**Item 1**
**6 Shackel Avenue Gladesville - LDA2021/0278**
**Alterations & additions to existing residential dwelling**
**Report prepared by:** Consultant Town Planner

**City of Ryde  
Local Planning Panel Report**

<b>DA Number</b>	LDA2021/0278
<b>Site Address</b>	6 Shackel Avenue, Gladesville NSW 2111 Lot 19 DP 10340
<b>Zoning</b>	R2 Low Density Residential
<b>Proposal</b>	Alterations and additions to existing residential dwelling.
<b>Property Owners</b>	Roumany Gadalla
<b>Applicant</b>	Roumany Gadalla
<b>Report Author</b>	Brendon Clendenning, Consultant Planner
<b>Lodgement Date</b>	16 August 2021
<b>Notification No. of Submissions</b>	Three (3) submissions received, all objecting to the proposed development.
<b>Cost of Works</b>	\$1,731,000.00
<b>Reason for Referral to LPP</b>	<b>Departure from development standards</b> – contravention of the height of buildings and floor space ratio development standards by more than 10% - <i>Schedule 1, Part 3 of Local Planning Panels Direction</i>
<b>Recommendation</b>	<b>Refusal</b>
<b>Attachments</b>	<b>Attachment 1</b> – Ryde DCP Compliance Table <b>Attachment 2</b> – Sydney Foreshores DCP Compliance Table <b>Attachment 3</b> – Building

**Proposed Plans  
Eastern  
Elevation**

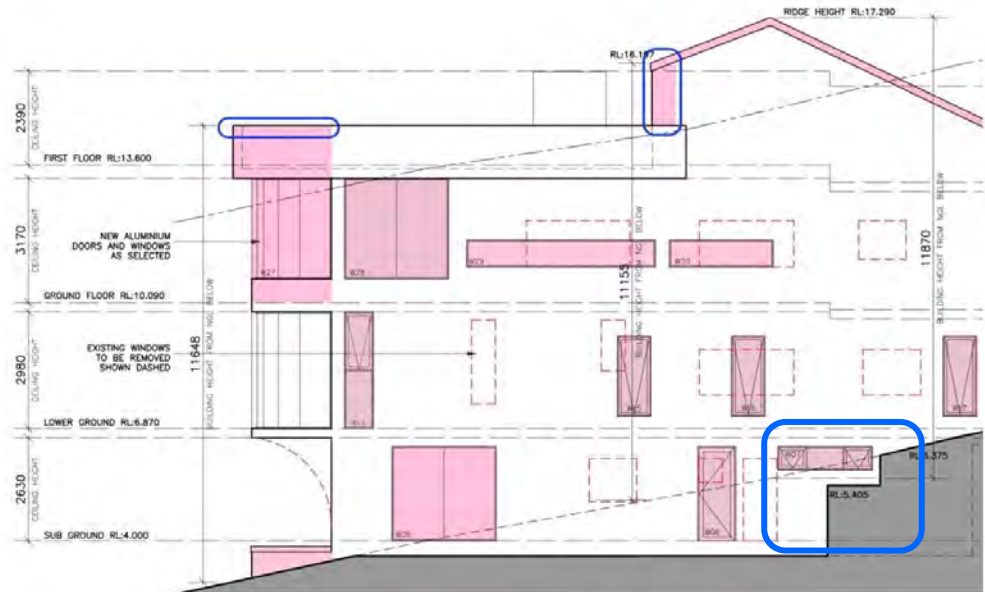
The additions proposed will not exceed the established maximum building height of the dwelling, however, a 300mm increase in the height of an existing balustrade level, and a proposed 600mm elongation of the building at the First Floor Level will require these building elements to exceed the prescribed 9.5 metre building height when projected as a plane from ground level (existing). Within the table below, the additions to the building are highlighted through a comparison between the plans approved within Building Application No. 1075/86, and the proposal:

The proposal seeks a 300mm increase in the height of an existing first floor terrace balustrade level, and a proposed 600mm elongation of the building at the First Floor Level, both as marked in blue above. The height measurements have been made from ground levels that may have existed before the dwelling was constructed (1980s), rather than the excavated levels now evident on site.

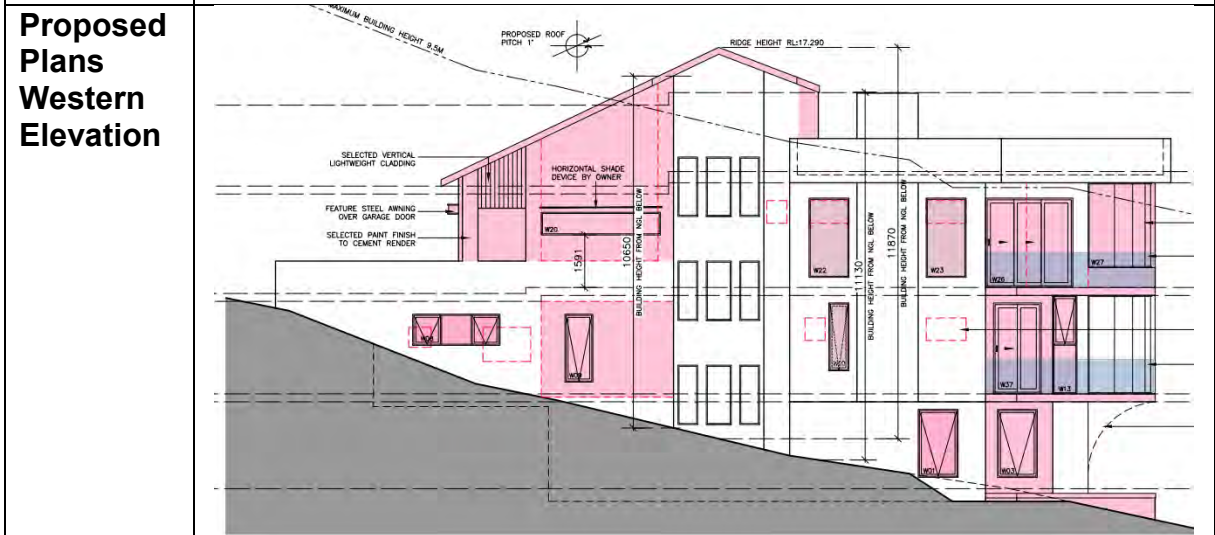
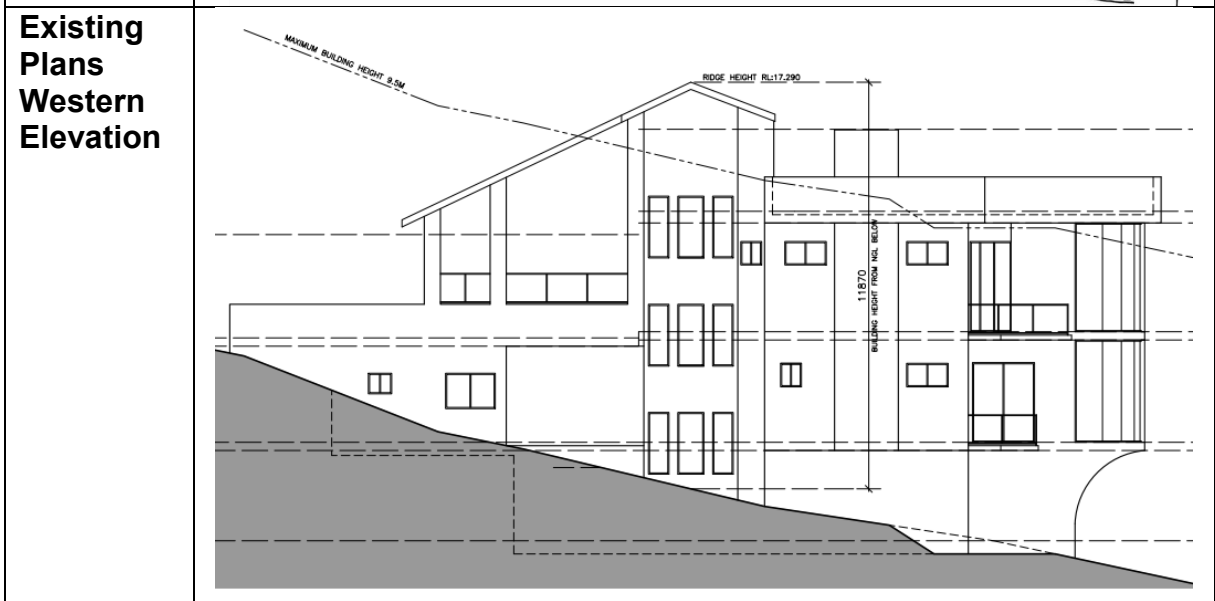
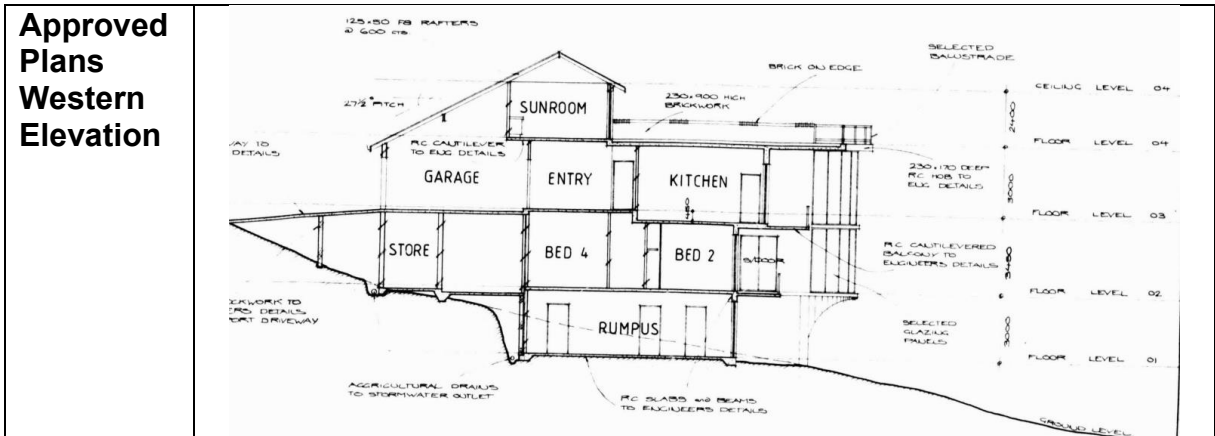
The above plans illustrate that further excavation is required under the building and at the western portion of the site to accommodate the subfloor. The additions will also create a continuous building height measured at 10.65m although “ground level (existing)” would be unchanged by this aspect.

The proposal also includes the addition of a lift to all floors; however, the plans do not illustrate if there will be a resultant lift overrun. The Statement of Environmental Effects

and response to RFI letter does not comment on the provision of a lift overrun. Should a lift overrun be required as part of any approval given, a condition would be recommended to indicate that an overrun is not part of this application as it is not identified within the plans provided.

FIGURES 2 & 3

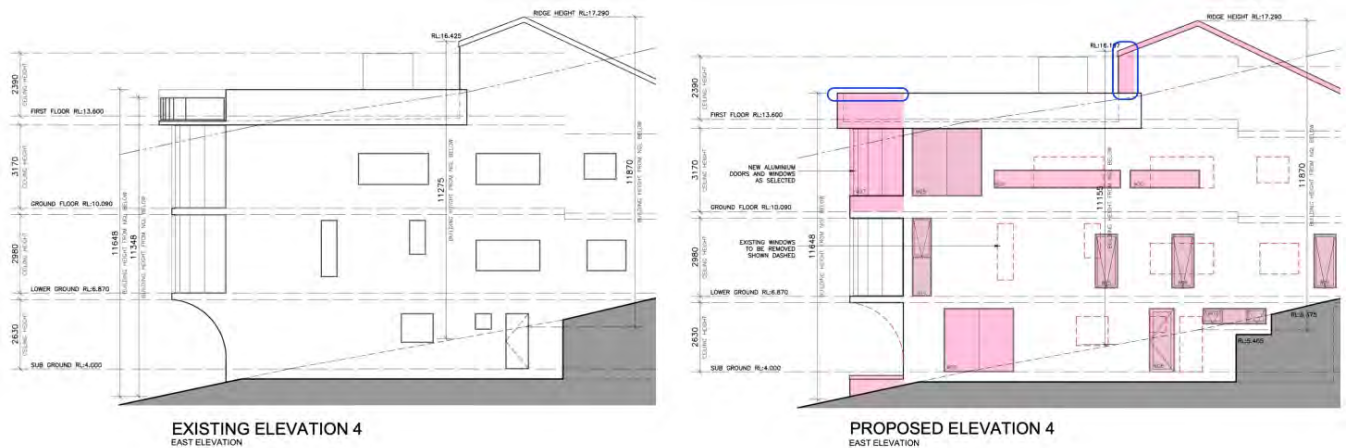
*“The alterations and additions proposed will not exceed the established maximum building height, however, a 300mm increase in the height of an existing balustrade level, and a proposed 600mm elongation of the building at the First Floor Level will mean these building elements exceed the prescribed 9.5 metre building height when projected as a plane from ground level (existing)”.*

*“The alterations and additions include changes to the First Floor Level balustrade (from glazing to brick) to improve BCA performance and safety, and elongation of the First Floor Level by 600mm to accommodate lift access throughout the building. The proposed modifications to the balustrade materials and composition locally increases building height by 300mm to 11.648 metres, representing only a 3.4% increase to the existing building height in this location, but represents a 22.6% variation to the development standard (see Figures 2 & 3 over page).*

**Figure 16:** Section of approved undercroft area, taken from approved plans

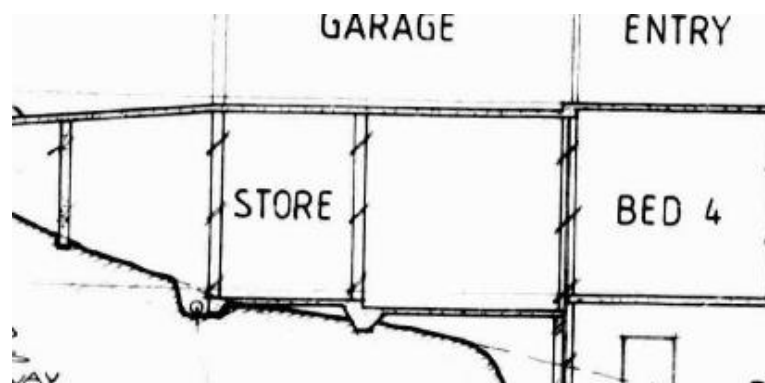
Further, the undercroft area is currently open on each end of the building; it is shown between the store and bed 4 and would be located towards the driveway in line with the lower windows shown in the image above. The image below shows that the previously approved plans depicted no cut within that location.

Referring to the image above, the area to the left of the 'store' is proposed to be included as GFA. This may require extra cut within the area beneath the driveway.

**Figure 18:** Approved plan of the Sub Floor Level from last approved works to the subject site on the left (Building Application No. 1095/86), in comparison to the proposed works and submitted Architectural Plans on the right

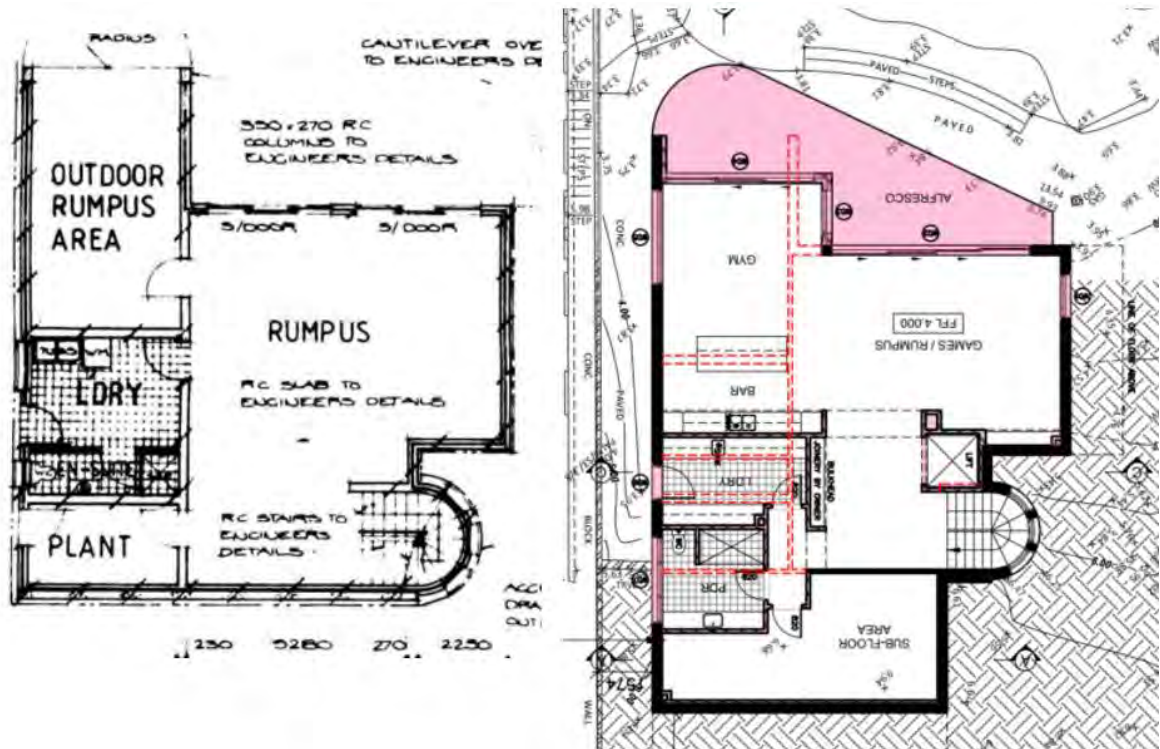
The sub-floor area is not marked for a non-habitable purpose and is provided with ceiling heights which match the remainder of this level. This area was not notated on the approval as part of the original building application, as demonstrated within the approved plans excerpted below within **Figure 18**.

The previously approved plans on the left show no subfloor area to the north of the approved plant room (bottom of page). However, the plan on the right indicates that the proposal seeks to expand into an existing subfloor area. The potential excavation and earthwork concerns surrounding this addition are discussed above.

The applicant was asked to provide information as to the extent of the proposed cut and fill proposed with the development. As seen in **Figure 18** above, an additional room is proposed to the north of the sub floor level that requires an extensive amount of cut and excavation. The applicant response to Council's RFI stated that no excavation was proposed. The proposal can therefore not be supported without proper information as to the extent of the proposed cut that can be seen between the latest approved plans and the proposed plans in **Figure 18**.

**Figure 19:** Existing (left) and proposed (right) GFA Calculations listed on the Architectural Plans

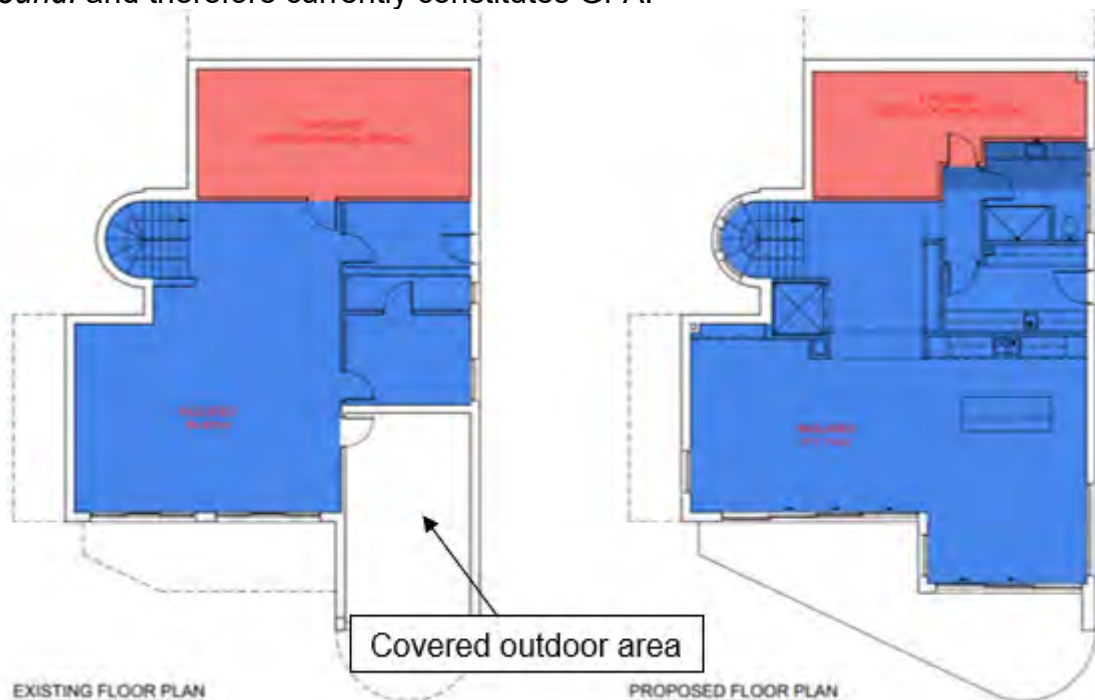
In addition to the above, Sheet 3 of the plans shows the existing and proposed Sub-Ground Floor Plan and identifies a *Covered Outdoor Area* which is not included in the applicant's existing GFA Calculations. The *Covered Outdoor Area* was previously approved as a 'outdoor rumpus area' with no wall to the south. This area is currently enclosed with a fourth wall as can be seen in **Figure** and *Error! Reference source not found.* and therefore currently constitutes GFA.

**Figure 21:** Extract of eastern elevation showing the existing maximum wall plate height (13.55m) and areas of further non-compliance to both the height in storeys and the wall plate height

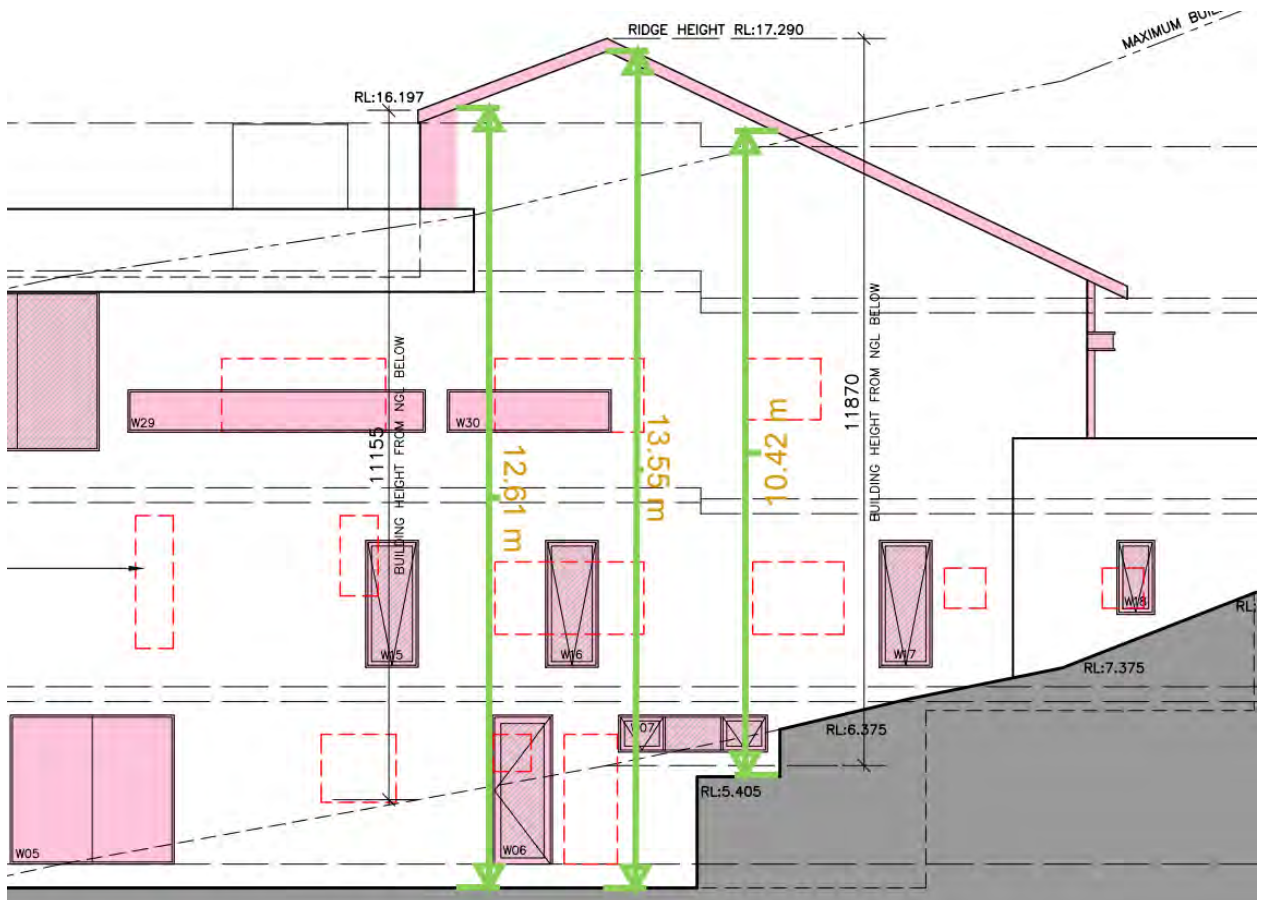
The proposal does not seek to increase either the number of storeys or the maximum wall height. However, due to additional cut to the north, adjacent to the lowest level of the development, and an extension in a southwards direction at the uppermost level, the proposal will increase the length of the four storey portion, as well as the extent of the wall plate height non-compliance.

The approximately 970mm of cut increases the wall plate height to approximately 10.42m in this location, and the rear addition to the upper floor is located at a point where the wall plate height already sits at approximately 12.61m. In both cases, the length of the four storey portion is also increased.

Figure 22: Architectural Plans extract showing a 2.39m ceiling height for the first floor.

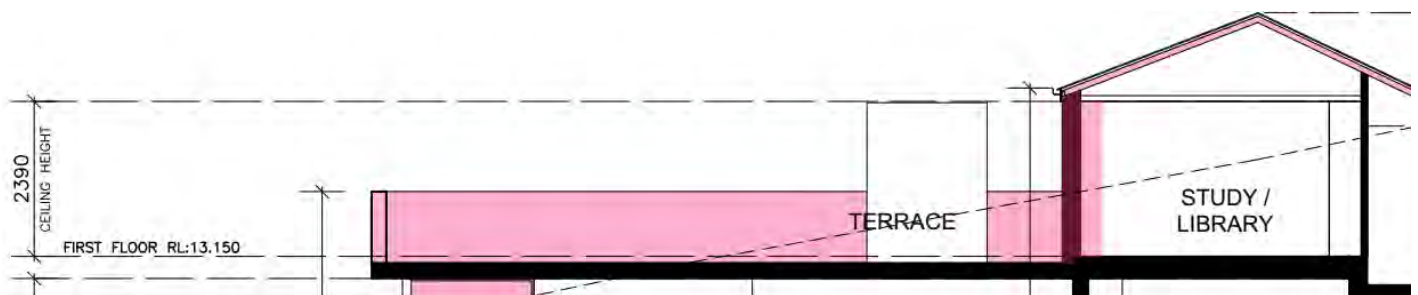
The proposal seeks to lower the ceiling height of the first floor study/library area to 2.39m (**Figure**) which is also accompanied by a new roof for the dwelling. This results in a non-compliant floor to ceiling height, noting that Section 2.8.2 of the RDCP 2014 requires a minimum 2.4m. Additionally, the approved ceiling height of the first floor is 2.4m. No reasoning or justification for lowering the ceiling of the first floor has been submitted. Non-compliance with the minimum floor to ceiling heights also results in a non-compliance with the minimum requirements for habitable rooms outlined within Part 3.8.2 Health and Amenity of the National Construction Code. No Building Code of Australia (BCA); a report has been provided to outline how this non-compliance will be resolved by a performance satisfy provision of the BCA.

Figure 24: 9am, 12pm and 3pm shadow diagrams submitted with the proposal

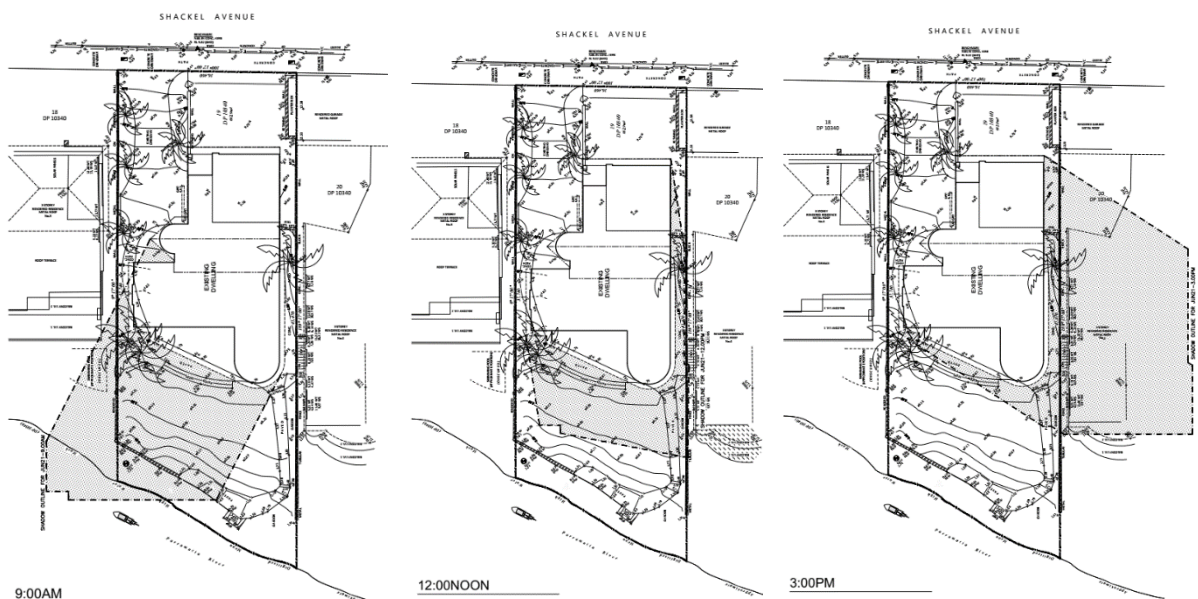
Shadow diagrams submitted with the amended proposal are shown below (hourly shadow diagrams were provided as requested within Council’s RFI, but for simplicity only 9am, 12pm, and 3pm shadow diagrams are shown below).
